## NATIONAL BOARD INSPECTION CODE COMMITTEE

## Minutes March 24 and 25, 2015

## Meeting of Sub Group Locomotives Location 1055 Crupper Ave Columbus, OH 43229

Figure S1.2.9.1-b

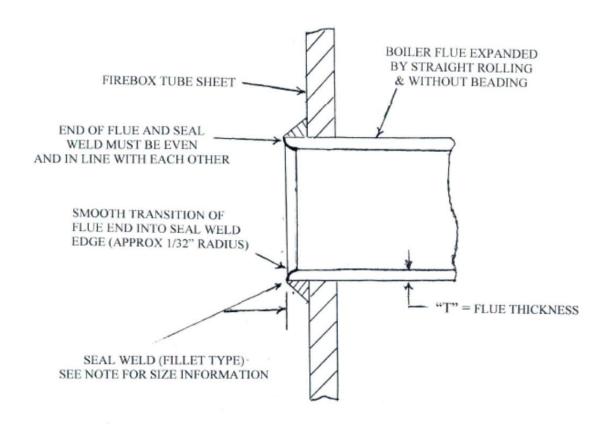
S1.2.9.1 Title: INSTALLATION OF BOILER FLUES (See Figures S1.2.9.1-a, S1.2.9.1-b, S1.2.9.1-c, S1.2.9.1-d & S1.2.9.1-e)

- r. When flues are installed by expanding straight and seal welding without beading, each flue shall first be expanded either partially or completely into the tube sheet hole then all accessible oil or lubricant shall be removed prior to seal welding. The tube sheet temperature shall not be less than 70°F (21°C) during the seal welding process. The seal weld size shall range between 1/8 in. 1/4 in. (3.2 mm 6.3 mm) based on the flue thickness unless the original design required different values be used. See Figure S1.2.9.1-b and ASME Code, Sec I, Part PFT, Figure 12.1 for additional information regarding the seal weld size for this flue

New Figures S1.2.9.1-a, S1.2.9.1-b, S1.2.9.1-c, S1.2.9.1-d & S1.2.9.1-e are attached and are to be included as part of this action.

Figure S1.2.9.1-e

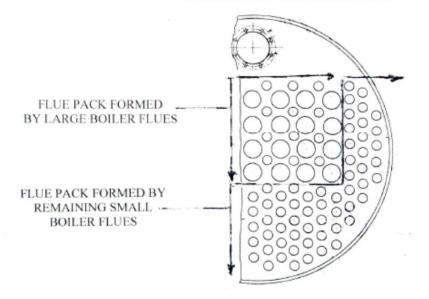
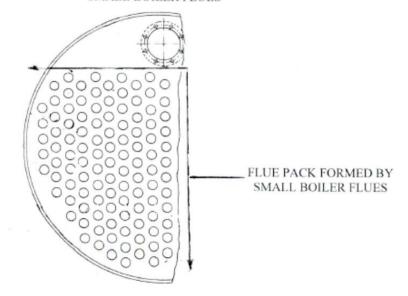
- n. At the front tube sheet, when the boiler is fitted with both large and small diameter flues, all flues that are 3 in. (76.2 mm) OD or larger shall be expanded and beaded. In addition, all flues smaller than 3 in. (76.2 mm) OD located within the flue pack formed by the large diameter flues shall be expanded into the front tube sheet and beaded.

All remaining flues in the front tube sheet that are smaller than 3 in. (76.2 mm) OD and located within the flue pack formed by the remaining small diameter flues shall be expanded and also shall be beaded per the number and location

- o. At the front tube sheet, when the boiler is fitted with only small diameter flues not exceeding 3 in. (76.2 mm) OD all flues shall be expanded and also shall be beaded per the number and location arrangement of the original design.

Figure S1.2.7-a

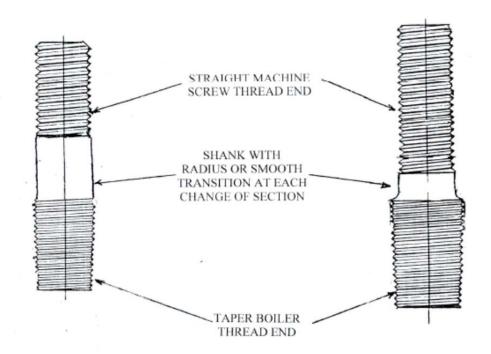
# **Revised title and section:** S1.2.7.2 TAPER THREAD BOILER STUDS (SEE NBIC PART 3, FIGURES S1.2.7.2-a, S1.2.7.2-b & S1.2.7.2-c)

Figure S1.2.7-c

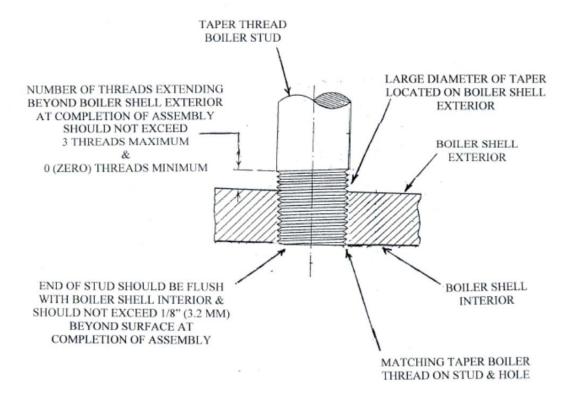
- b) When taper thread boiler studs are installed into blind holes on the boiler shell or sheet the taper section length shall be confirmed to be shorter than the hole depth in order to prevent the stud from contacting the hole bottom upon being tightened at final assembly.

Figure #1

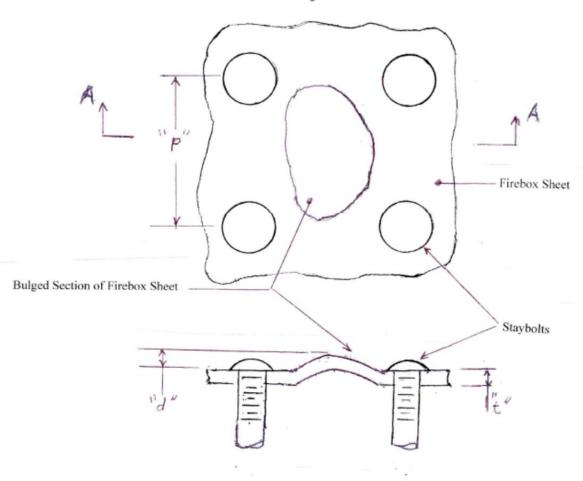
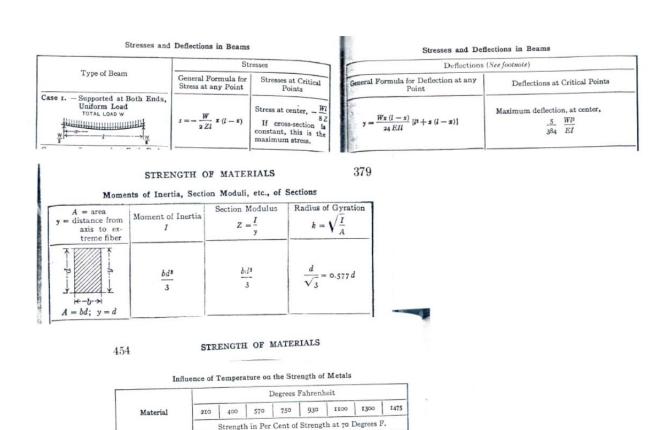
The formulas and terms are explained in detail in the section "Analysis Method. The calculations for results listed in Table #1 are in the section "Calculations for Table #1". In addition, see Figures #1 & #2.

- 1. The bulged section of the firebox sheet is analyzed as a simply supported beam that is uniformly loaded by the boiler pressure. Each end of the beam is assumed to be supported by the staybolt located at each end of it.
- 2. The beam width (b) is taken as a 1 in. (25 mm) wide section of the firebox sheet. The beam length (p) is the horizontal or vertical pitch distance of the staybolt pattern (the centerline distance of the two staybolts at the bulge location on the firebox sheet). The choice between the use of the horizontal or vertical pitch distance is dependent on the orientation of the bulge.

Figure S1.2.9.7

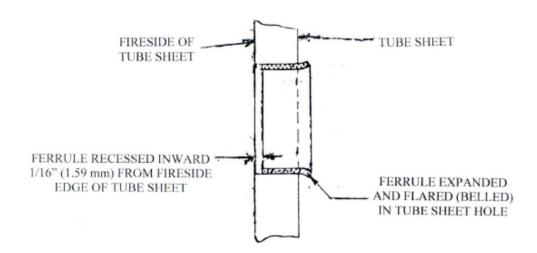
NBIC Part 3 Paragraph(s): S1.2.9.7 Title: Ferrules (Figure S1.2.9.7)

Committee generated to correct errors in existing text, add additional information to the document and add a new figure to the document.

New Figure S1.2.9.7 is attached and is to be included as part of this action.

Figure S1.2.2-b

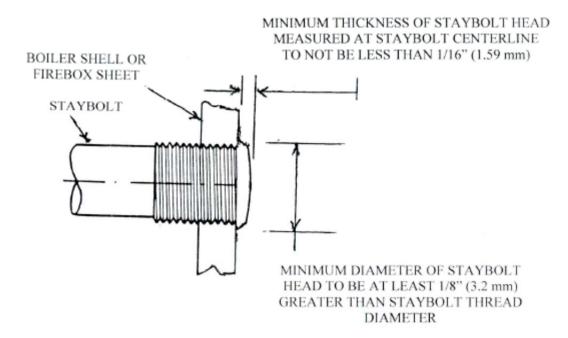
Committee generated to correct problems reported by NBIC users understanding Figure S1.2.2-b "Riveted Staybolt Head Dimensions" and to add new Figure S1.2.2-c "Threaded Staybolt Inspection" to section S1.2.2 Threaded Staybolts.

- 1. NB14-1802 Title: Riveted Staybolt Head Dimensions & Figure S1.2.2-c Title: Threaded Staybolt Inspection (pgs 50,51) Motion to return to the requestor and have this revised to be incorporated into Part 2 Inspection Rules. This information is not specific to Locomotives. R. Stone is PM. Passed unanimous
